May 14, 2011

Subject: SAVE OUR HERITAGE ORGANISATION (SOHO) PHASED ALTERNATIVE DESIGN
FOR THE PLAZA DE PANAMA, CIRCULATION AND PARKING PROJECT.
BALBOA PARK, SAN DIEGO, CALIFORNIA.

Image 1: Overall concept plan view of the proposed project.

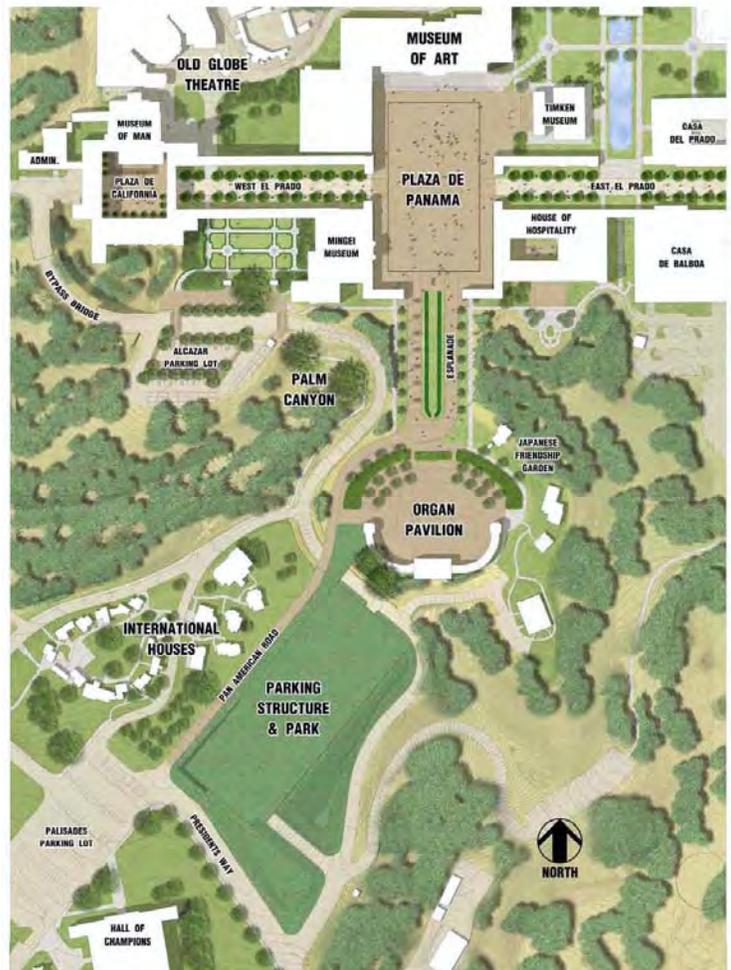
Image 1 from the HAP report does not include the proposed Tram Turn-Around at the Palisades Parking lot which unnecessarily impacts 24 existing accessible and standard parking spaces, usable turf/open space, and Palm trees south of the International Houses.

Image 18: Conceptual bird's eye rendering, looking northeast, showing the bypass bridge and related abutments. This drawing shows the general size and location of the bridge.

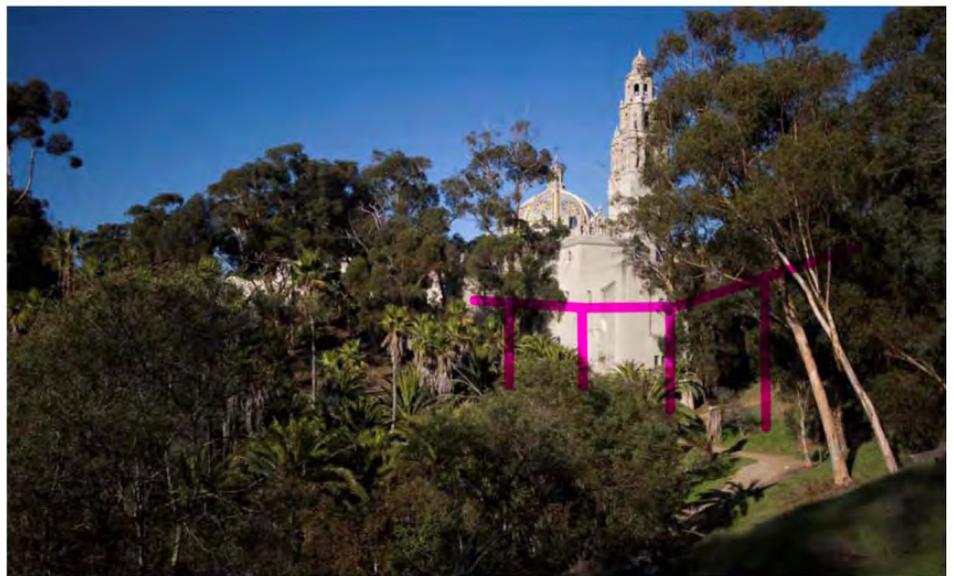
Mayor Sanders' Historic staff has determined that the construction of the bypass bridge results in an intrusion into the district that adversely impacts the setting and feeling of the Historic District and alters Historic spatial relationships.

.Images 15 and 12 from the HAP report.

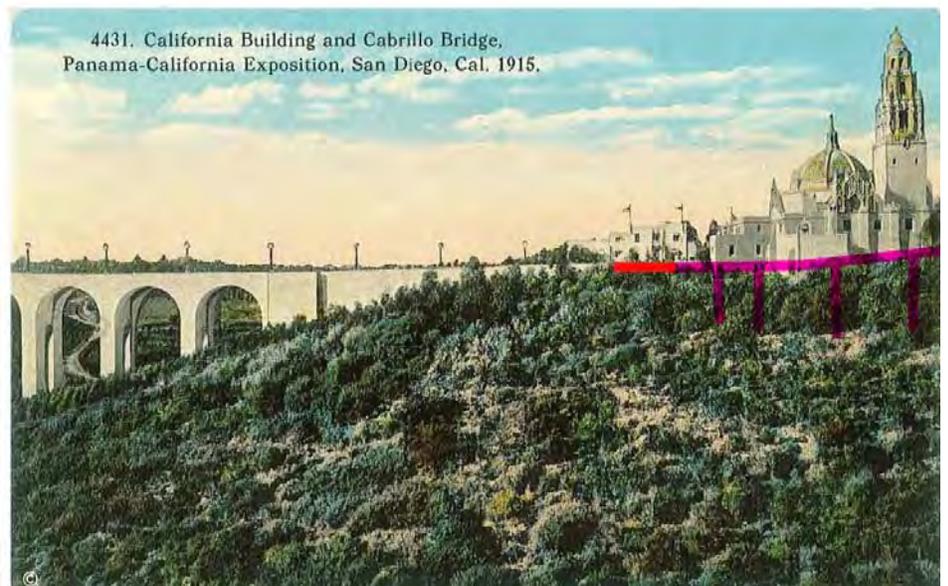
Image 15 from the HAP report, showed mature trees, but not the view of the proposed Bypass Bridge.

The new Bypass Bridge and column supports in pink from Cabrillo Bridge to Alcazar Gardens are superimposed on Image 15.

Goodhue's plan to depict the approach to a *“fortified European town”* is interrupted.

Image 12 from the HAP report, showing the location along the Cabrillo Bridge Abutment where changes are proposed in red, but does not include the Bypass Bridge.

Therefore, the proposed Bypass Bridge and column supports from Cabrillo Bridge to Alcazar Gardens are superimposed on the HAP Image 12 in pink.

SOHO contends that any bridge across the southwest façade is unacceptable and is contrary to the Secretary of the Interior's Standards for the Treatment of Historic Properties.
